**Transport**  
Roads & Maritime  
Services

# **FAUNA CONNECTIVITY REPORT (TABLE 6.2)**

## **Oxley Highway to Kundabung**

**DECEMBER 2014**

Culvert CH 1600 and CH 1640

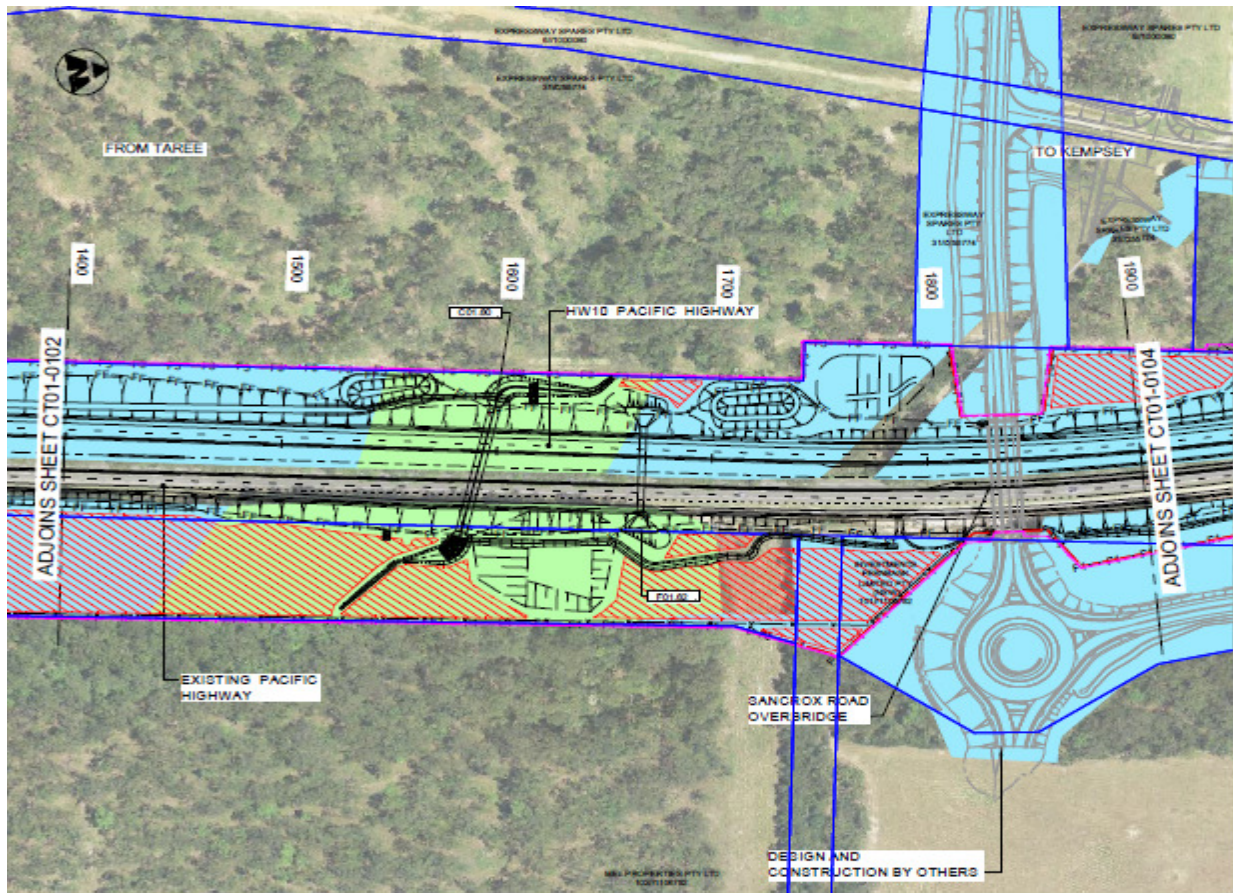
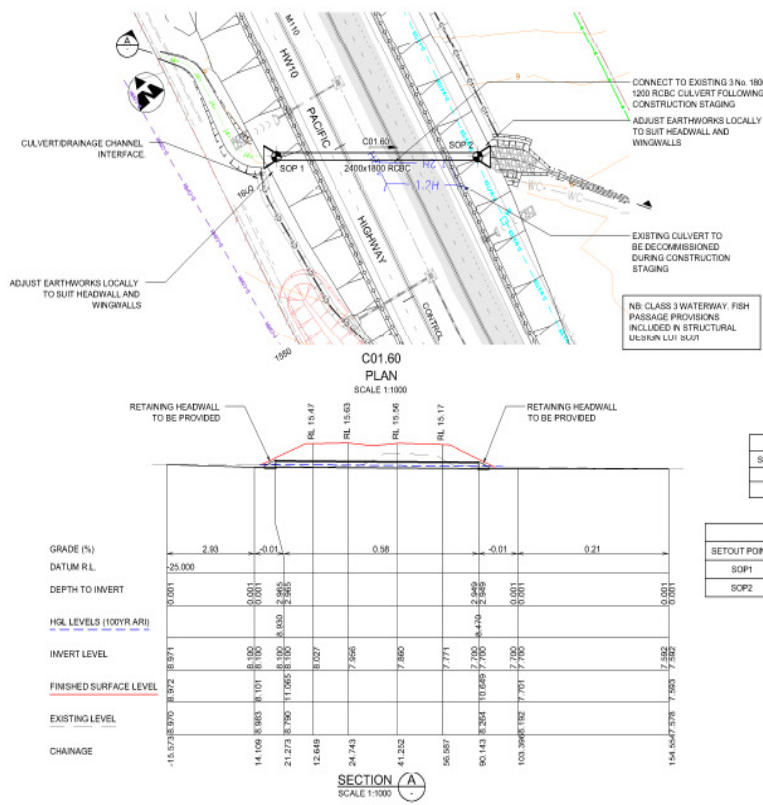
<b>Location: C1.60</b>	
Crossing type:	Incidental
SWTC Table 6.2 location	CH 1600
SWTC Table 6.2 Structure form	Box culvert – One structure for incidental use.
SWTC Table 6.2 dimensions	4 Cells, 1.8m wide x 1.2m high
Original location vegetation	Moist Gully Forest (NB) Moist Gully Forest (SB)
Watercourse	Class 3
Connectivity value	Very High – Subregional corridor
Proposed location	Unchanged
Proposed structure	Unchanged
Proposed dimensions	2 cells, 2.4m wide x 1.2m high
New location vegetation	Unchanged
Reason for design change	<p>The culvert has been reduced from four cells to two cells due to detail design identifying that hydraulic flows would not be as significant as detailed in the concept design. However, the sizing of the cells has increased to 2.4m x 1.2m. The new culverts meet the hydraulic requirements required under the deed while minimum open envelope required for fauna passage as specified in SWTC is maintained.</p> <p>Fish passage has been achieved through the use of a low flow channel and use of rip rap and associated regrade of both inlet and outlets to tie the drainage line into surrounding watercourses and vegetation.</p>

<b>Location: F1.62</b>	
Crossing type:	Dedicated
SWTC Table 6.2 location	CH 1640
SWTC Table 6.2 Structure form	Box culvert
SWTC Table 6.2 dimensions	1 Cell, 3m wide x 3m high
Original location vegetation	Moist Gully Forest
Watercourse	N/A
Connectivity value	N/A
Proposed location	Ch 1660
Proposed structure	Unchanged
Proposed dimensions	Unchanged
New location vegetation	Moist Gully Forest (NB) Moist Gully Forest (SB)
Reason for design change	The culvert has been relocated to provide dry passage above the 100 ARI flood level to meet both EPBC condition 3 requirements.
Engineering considerations:	Length of the culvert has reduced to approximately 48m from 52m and has been designed to reduce skew (which reduces overall length) and facilitate dry passage. The reduction in length and skew also translates to a net reduction in complexity and construction footprint thus reducing clearing.
Ecological outcome:	Neutral biodiversity outcome.

Culvert CH 6330

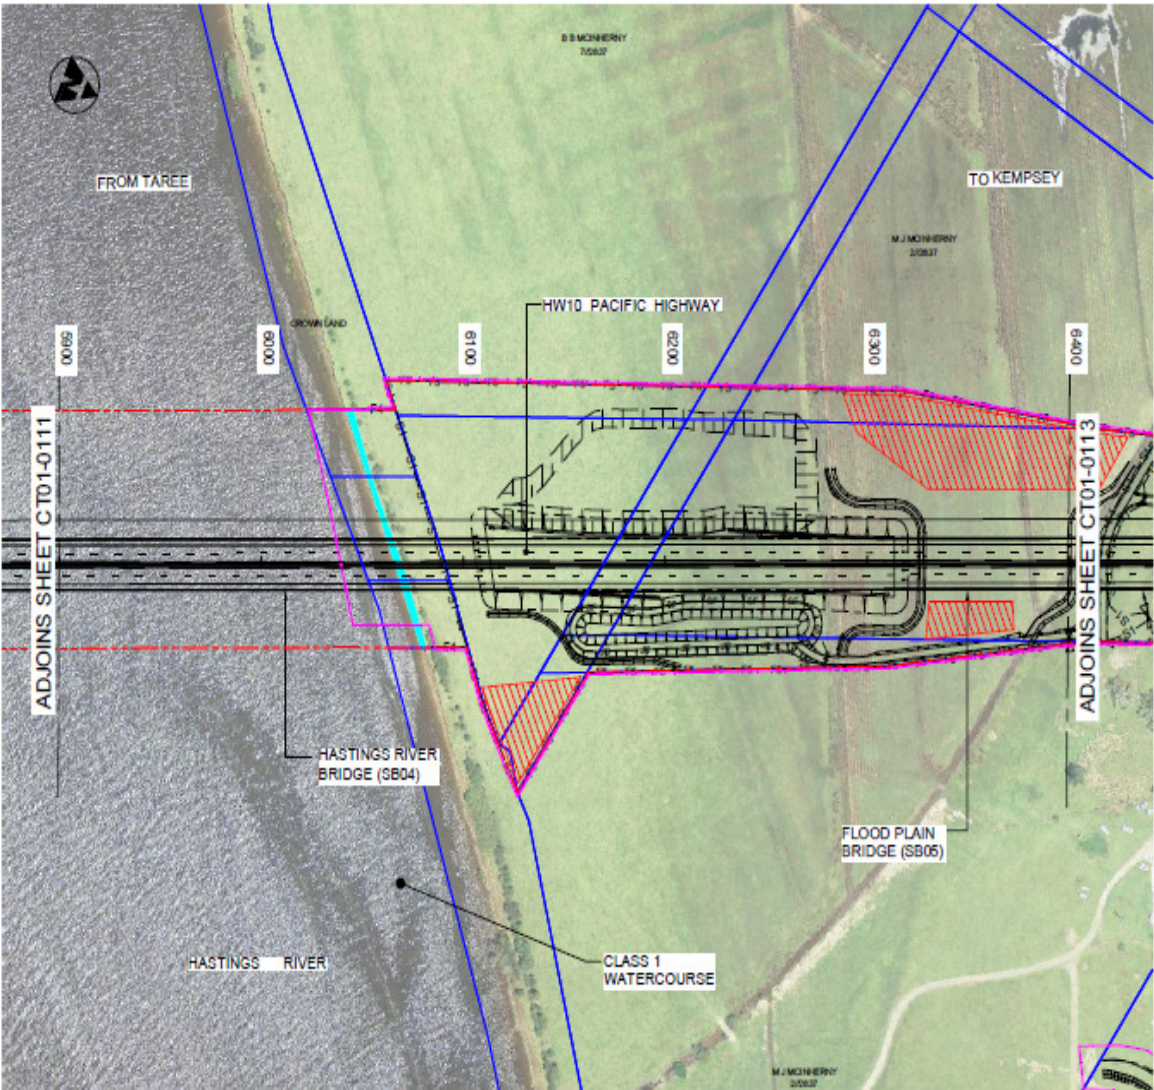
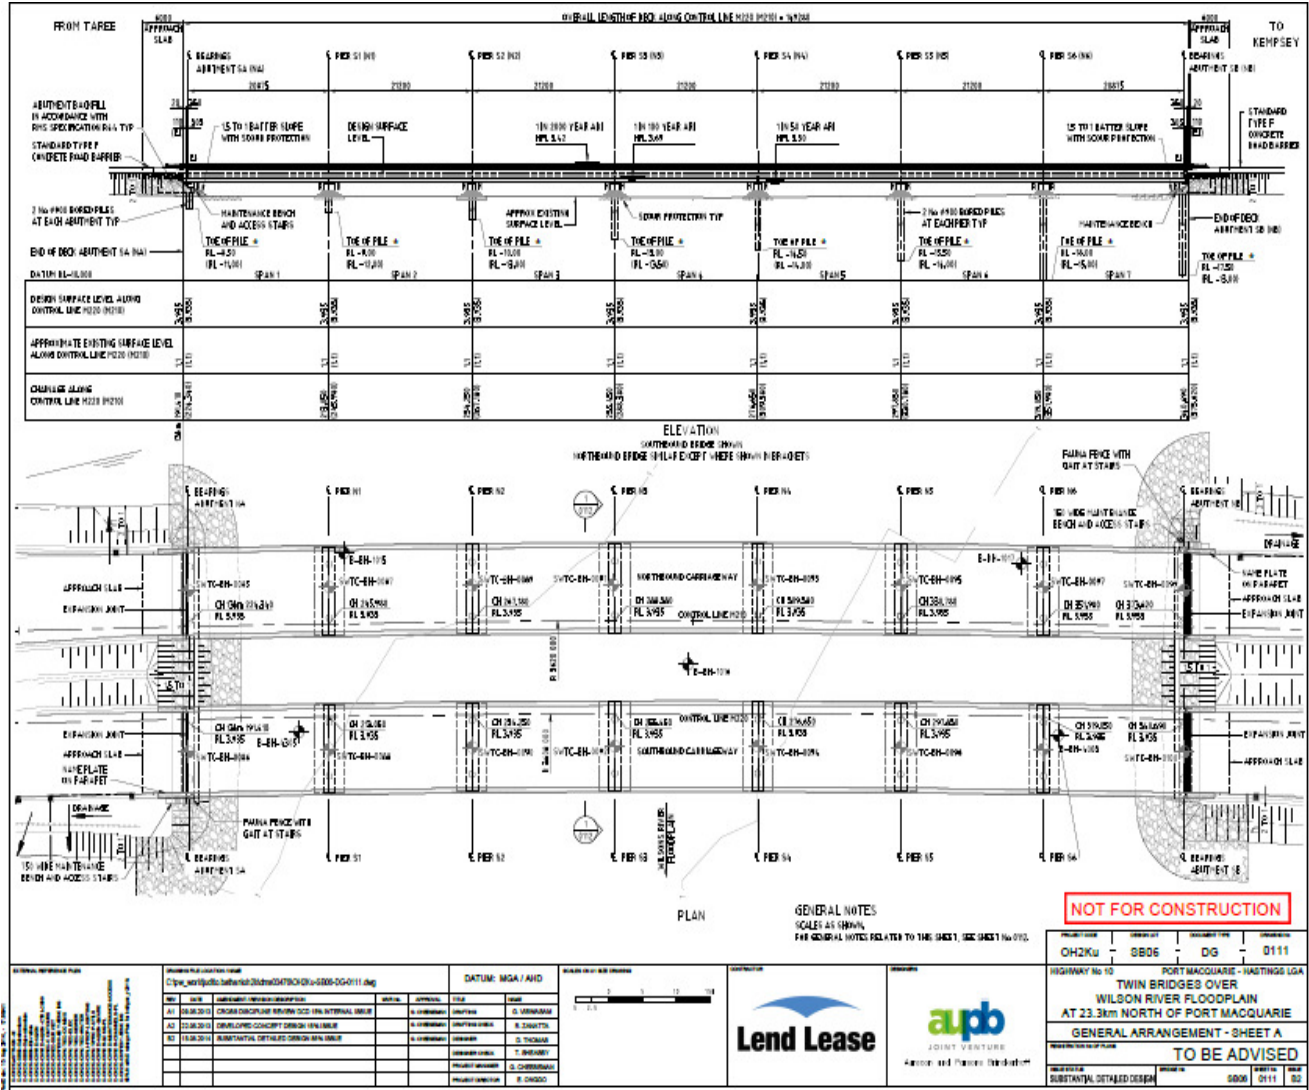
Culvert C6.30 was originally specified to be a box culvert. However, at this location, due to flooding behaviour, a bridge structure was required. In addition, the inclusion of a bridge instead of a culvert would provide a more beneficial outcome in terms of fauna passage.

<b>Location: C6.30</b>	
Crossing type:	Combined/ flood relief
SWTC Table 6.2 location(s)	CH 6330
SWTC Table 6.2 Structure form(s)	Box culvert
SWTC Table 6.2 dimensions(s)	1 Cell, 3m wide x 3m high
Original location vegetation	Cleared land
Watercourse	N/A
Connectivity value	N/A
Proposed location	CH 6320-6460
Proposed structure	Floodplain bridge structure
Proposed dimensions	30.6m (fauna passage under structure)
New location vegetation	Cleared land
Reason for design change	Culvert was changed to a bridge structure to provide improved hydraulic and flooding performance.
Engineering considerations:	
Ecological outcome:	Neutral biodiversity outcome.
Fauna exclusion fencing provisions	There is no fauna exclusion fencing at this location. The purpose of the structure is to provide connectivity for small animal species that live in and around the creek line.

Culvert CH 7260

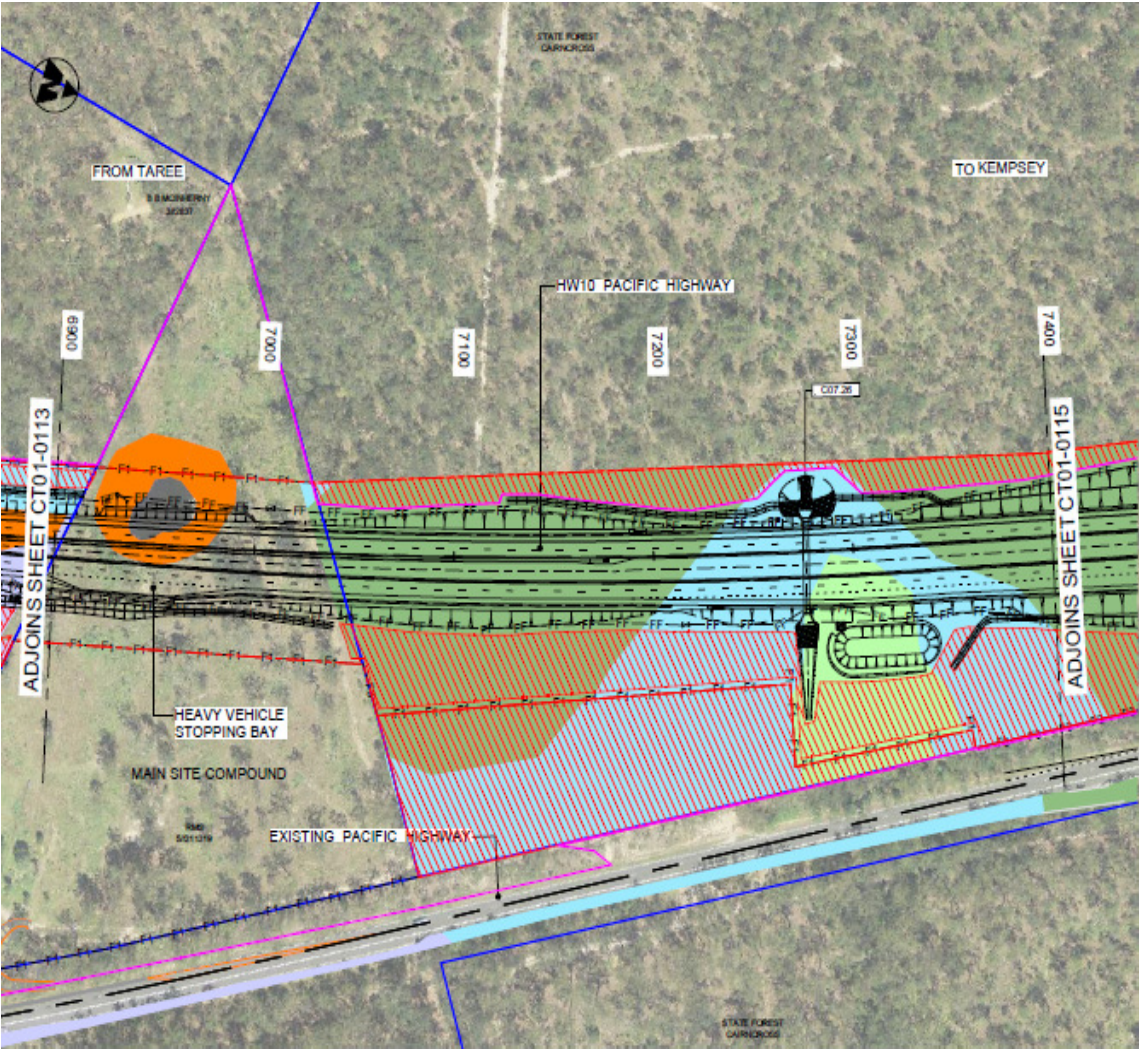
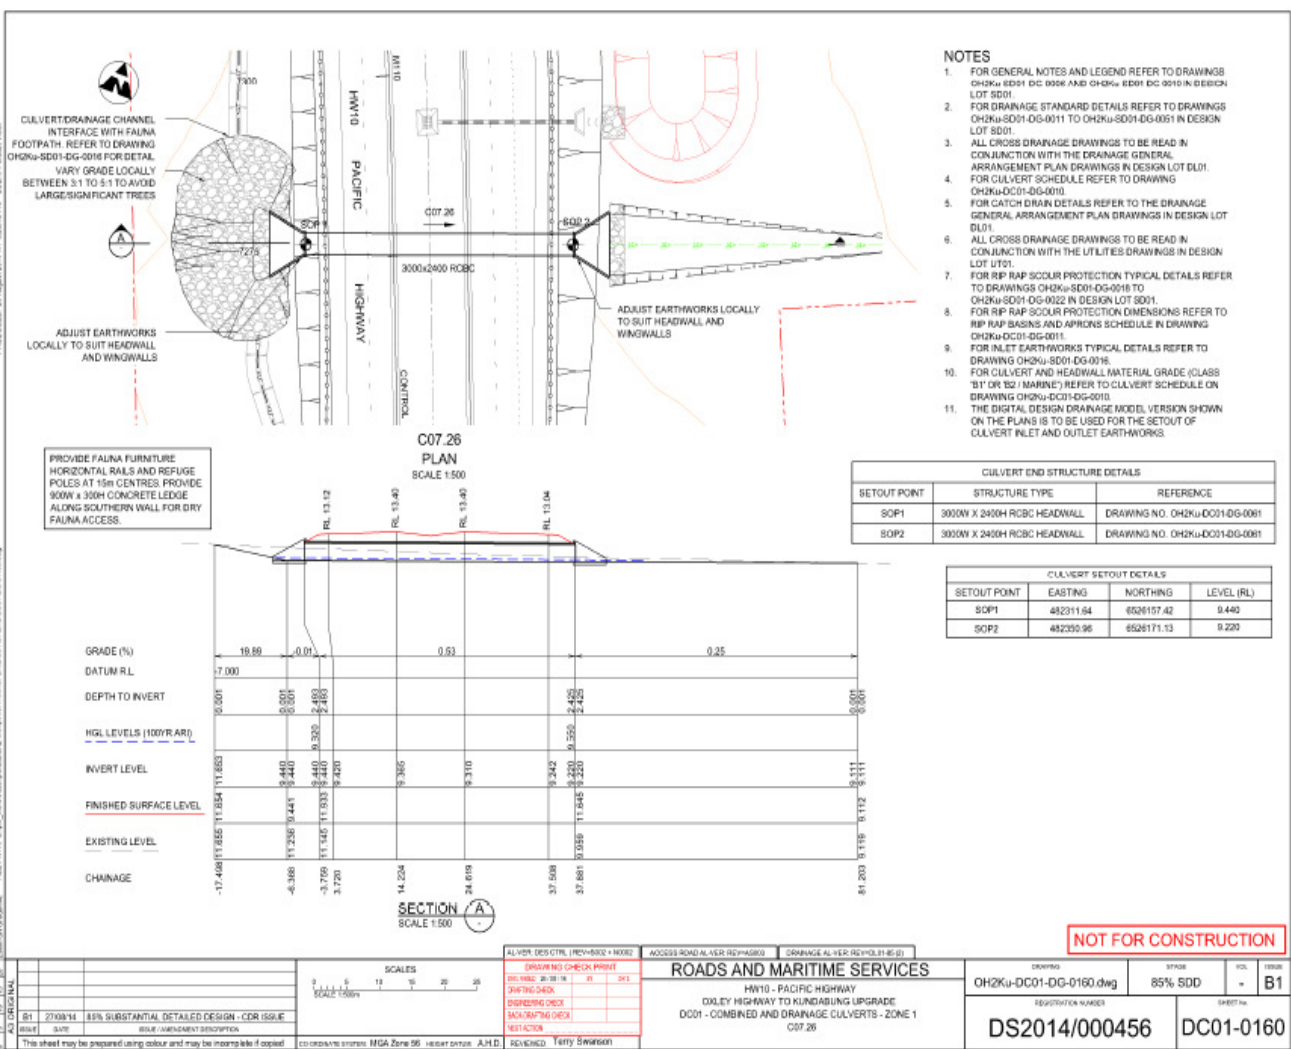
<b>Location: C07.26</b>	
Crossing type:	Combined
SWTC Table 6.2 location(s)	CH 7260
SWTC Table 6.2 Structure form(s)	Box culvert
SWTC Table 6.2 dimensions(s)	1 Cell, 3m wide x 2.4m high
Original location vegetation	Moist Slopes Forest (NB) Moist Gully Forest (SB)
Watercourse	N/A
Connectivity value	Medium- links vegetation with State Forest
Proposed location	CH 7270
Proposed structure	Unchanged
Proposed dimensions	C2.60B: 2 cell 3.0m wide x 2.1m high
New location vegetation	Moist Slopes Forest
Reason for design change	Shift north has resulted in a substantial reduction in length of the culvert.
Engineering considerations:	Relocation requires a regrade on the western side (about 1 in 7 metres for 16m).
Ecological outcome:	Positive biodiversity outcome.
Fauna exclusion fencing provisions	A Fauna fence runs alongside the highway at the base of the formation along both carriageways. Fencing will be located over the top of the headwall of the crossing allowing this culvert to be used by fauna. Rails and refuge poles as originally identified will still be provided  Drop down structures will be provided in locations in close proximity to the underpass, as agreed with the project ecologist and confirmed onsite with OEH.

22/C7.26	7260	Combined	Slight increase in length from 43.2m to 53m.	Increased length due to raised vertical alignment that results in longer batter	No consultation to date regarding this change.
